Our Ref: F2012/00089

**PLANNING PROPSOAL: ROYAL RANDWICK RACECOURSE
REF: (PP_2012_RANDW_001_00); &**

**STATE SIGNIFICANT DEVELOPMENT APPLICATION: ROYAL RANDWICK
HOTEL REF: (SSD 5002-2011)**

a) View from Alison Road looking west

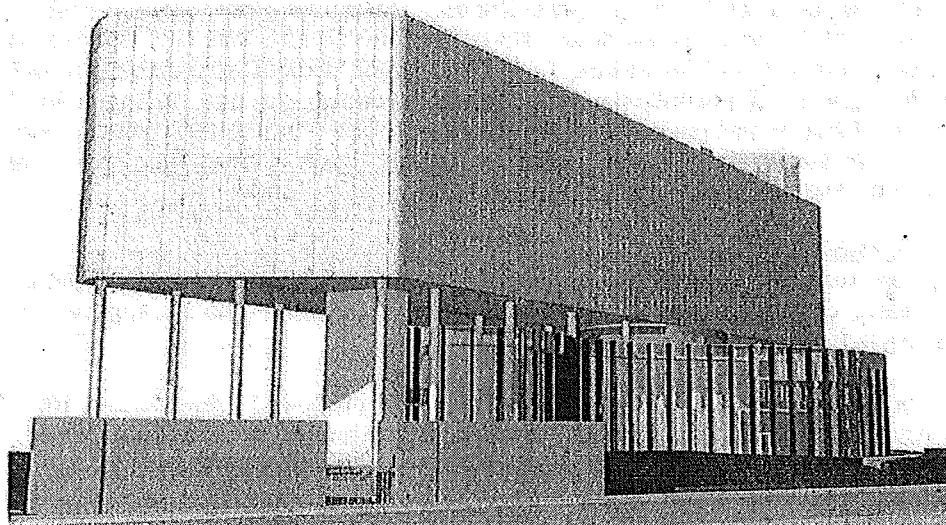
Improved integration of articulating and modulating elements is essential to improving the appearance and relationship of the development to the public realm. The current scheme attests to a 'closed façade fronting Alison Road' to offset acoustic impacts. This approach omits any relief to the presentation of the building envelope, accentuating the mass and horizontality of an elevated box to the adjoining public spaces.

The external materials used relate poorly to the heritage Turnstile and Members Stand structures, as well as the adjoining heritage conservation areas the building dominates. The use of a graphic decal to provide visual interest is

unsatisfactory for a development of this size, prominence or within such immediate proximity to elements of heritage significance. The proposed equine decals are not reflective of a high quality landmark development, of which the applicant seeks.

Large spans of glass will introduce distracting glare to motorists on the busy thoroughfare of Allison Road, as acknowledged by the applicant's reflectivity consultant. The extensive use of glazed surfaces and absence of screening will incite heavy reliance upon mechanical ventilation, given unobstructed solar exposure to the north and west elevations, where the proposed suites make use of these elevations to obtain views.

The façade treatment requires substantial redesign to improve visual interest in the hotel component of the building, make some effort to offset bulk and scale and improve the interface of the development with the street. The applicant should investigate a façade treatment of greater lifespan and quality than the proposed equine themed decals, providing articulation, glare offset and relief from solar exposure.
